Upper Trishuli-1 HEP (216MW)

DOOSAN NEPAL BRANCH OFFICE	Address & Contact No. : Four Square Building, Naxal, Kathmandu, Nepal (P.O Box : 1387) + 977 1 692 3014	Project No. H20002	DOCUMENT DISPATCHED BY Courier Service ☐ Messenger ☐ Post-Air Freight ☐ Document System or E-mail ■ By hand ■
DOCUMENT DISTRIBUTION	■ POWER CHINA (Subcontractor) ☐ Doosan's Site Office		
SUBJECT	Review Note RN-0214_Reinforcement Drawing of Diversion Tunnel Lining

REVIEW NOTE

Contractor	**Doosan Enerbility**		
Title of the Document	Reinforcement Drawing of Diversion Tunnel Lining		
Document/Drawing No.	UT1-C-010-CVL-DG-42006	Revision	0D
Date of Documents/Drawings	02.08.2022	Received Date	02.08.2022
Transmittal Form No.	UT1-HEP-DHI-D-0331		
Previous Review Date/Status	16.07.2022/RR	Prev. Review Note No.	RN-0182
Review Note No.	**RN-0214**	**Present Review Date**	**10.08.2022**
		Present Review Status	**AN**

Typical Cross Section D3
(for rock class III)
(for chainage 06.000 to 020.000)

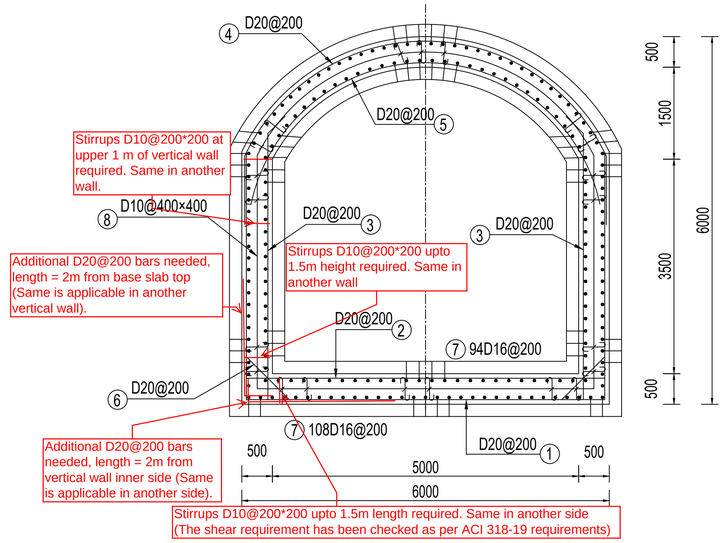
4 D20@200
D20@200 5
Stirrups D10@200*200 at upper 1 m of vertical wall required. Same in another wall.
D10@400×400
8
D20@200 3
D20@200 3
Stirrups D10@200*200 upto 1.5m height required. Same in another wall
Additional D20@200 bars needed, length = 2m from base slab top (Same is applicable in another vertical wall).
D20@200 2
7 94D16@200
D20@200 6
7 108D16@200
D20@200 1
Additional D20@200 bars needed, length = 2m from vertical wall inner side (Same is applicable in another side).
500
5000
500
6000
Stirrups D10@200*200 upto 1.5m length required. Same in another side
(The shear requirement has been checked as per ACI 318-19 requirements)
500
1500
3500
500
6000

This shall be applicable to the water side only. The cover on the rock side could be 50mm. Adopting higher cover on both sides would reduce the section strength drastically.

The stirrups size needs to be different for base slab and walls

Typical Cross Section D3

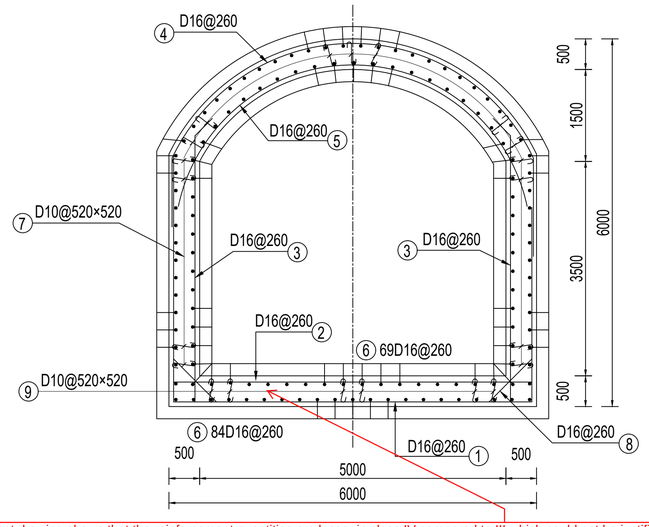
The reinforcement drawing shows that the reinforcement quantities are lesser in class IV compared to III which could not be justified by the calculation. With reference to the submitted structural design report (UT1-C-010-CVL-DC-42005_0D Structural Calculation of DT Lining) also, the moment is higher in class IV with respect to Class III rock. The analysis from the SAP also shows slightly higher reinforcement requirement for class class IV. Hence, the reinforcement of class IV lining shall be at least equal to class III reinforcement as suggested by the consultant.
